# HYUNDAI

## Technical Service Bulletin

GROUP <b>AUTOMATIC TRANSMISSION</b>	NUMBER <b>22-AT-011H</b>
DATE <b>OCTOBER 2022</b>	MODEL(S) <b>VELOSTER N (JSN) SANTA FE (TMA PE) SONATA (DN8a) SANTA CRUZ (NXT) KONA N (OSN) ELANTRA N (CN7N)</b>

**SUBJECT:** 8-SPEED WET DCT REPLACEMENT INSTRUCTIONS

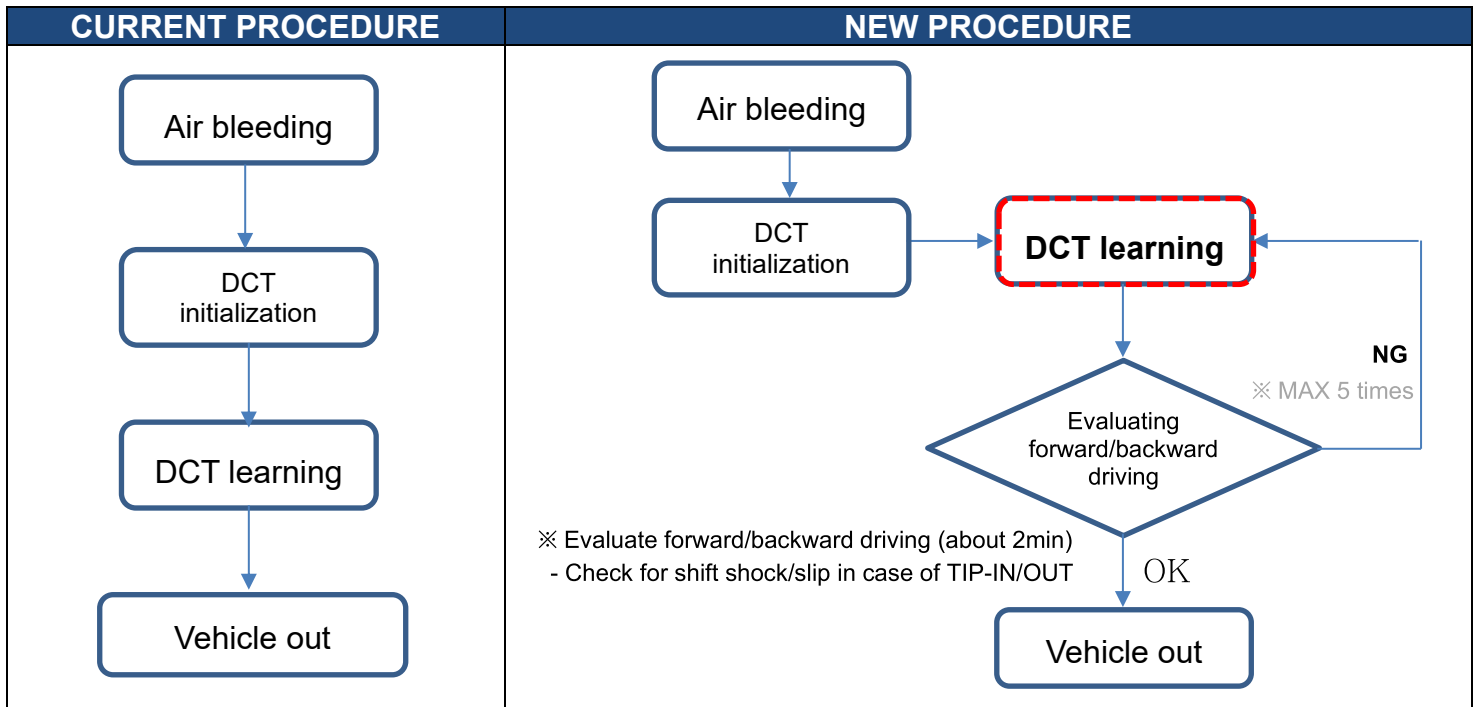
1. Prior to replacing a DCT/TCM, it is necessary to to perform the “Line Pressure Removal” mode in GDS.

If the “Line pressure removal mode” is not performed, drivability concerns and warning lights/DTCs can occur (P193B79, P0868, rattling/shift shock, unable to drive forward/reverse).

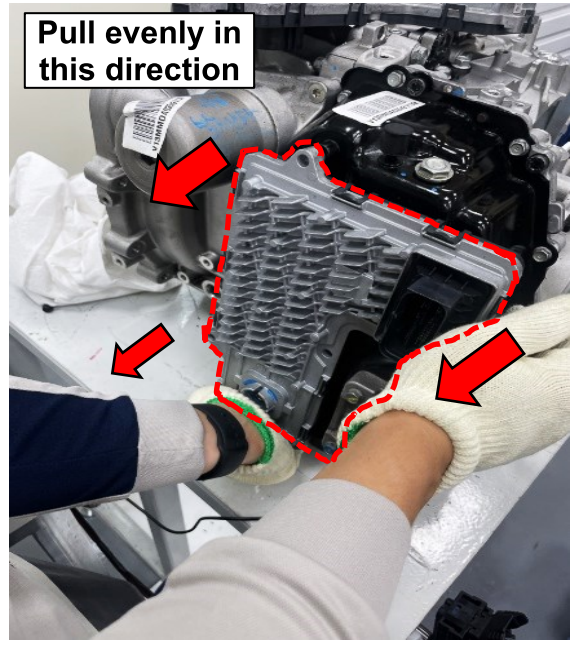
1. Remove the DCT TCM according to the vehicle shop manual.

**CAUTION**  
Make sure the TCU 24-pin terminal is aligned properly during removal/installation, otherwise the pins may get damaged.

**Male terminal of TCM**

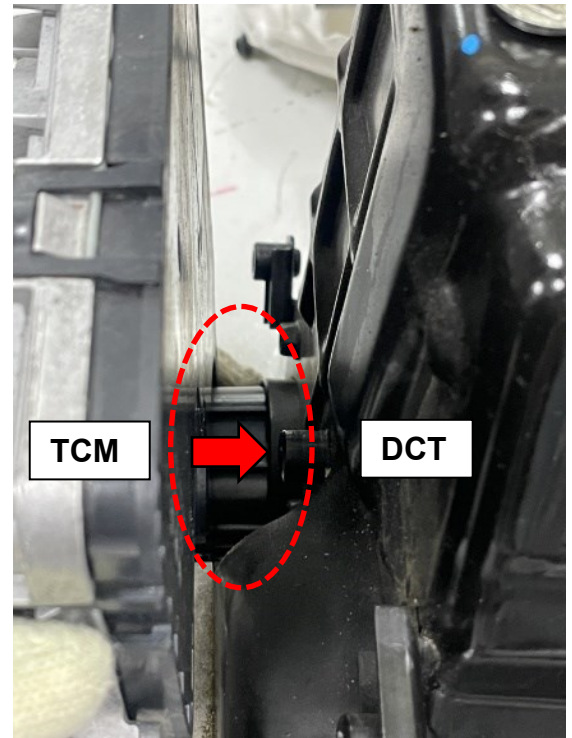
2. When reinstalling the TCM, make sure to align the connector on the TCM to the E-module on the DCT.
